# Access Compliance Report

## Public Rights-of-Way

### (Curb Ramps)

Intersection ID: 10022596	Main Street: CARMEL_RD	Cross Street: N/A	Location: SW
ADA ID: 17A18276D4C5	Ramp Type: Para	Initial Pass/Fail: Fail	Overall Compliance: No
			Severity Score: 13.75

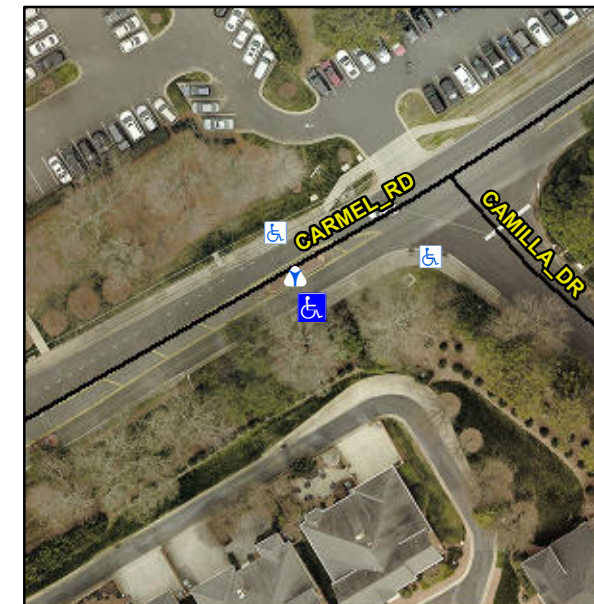
**R304.3.2, R304.5.3**

Compliance	Description	Data	Compliance	Description	Data
N/A	Ramp Length LT (in)	<b>69.0</b>	N/A	Ramp Length RT (in)	<b>72.0</b>
Yes	Ramp Width LT (in)	<b>53.0</b>	Yes	Ramp Width RT (in)	<b>53.0</b>
Yes	Ramp Slope LT (%)	<b>6.5</b>	No	Ramp Slope RT (%)	<b>8.6</b>
Yes	Ramp XSlope LT (%)	<b>1.1</b>	No	Ramp XSlope RT (%)	<b>2.5</b>
N/A	Landing Length (in)	<b>N/A</b>	N/A	DWS Provided?	<b>N/A</b>
N/A	Landing Width (in)	<b>N/A</b>	N/A	DWS Contrast?	<b>N/A</b>
N/A	Landing Slope (%)	<b>N/A</b>	N/A	DWS Length (in)	<b>N/A</b>
N/A	Landing X Slope (%)	<b>N/A</b>	N/A	DWS Full Width?	<b>N/A</b>
N/A	Landing Curb? (Y/N)	<b>N/A</b>	N/A	DWS Offset (in)	<b>N/A</b>
N/A	Shared Landing?	<b>N/A</b>			
N/A	Gutter Ponding?	<b>N/A</b>	N/A	Gutter Slope (%)	<b>N/A</b>
N/A	Gutter Lip Ht (in)	<b>N/A</b>	N/A	Gutter X Slope (%)	<b>N/A</b>
N/A	Painted X Walk1?	<b>No</b>	N/A	Painted X Walk2?	<b>N/A</b>
	X Walk 1 Direction	<b>To NW</b>		X Walk 2 Direction	<b>N/A</b>

**Remove & Replace Entire Ramp.**
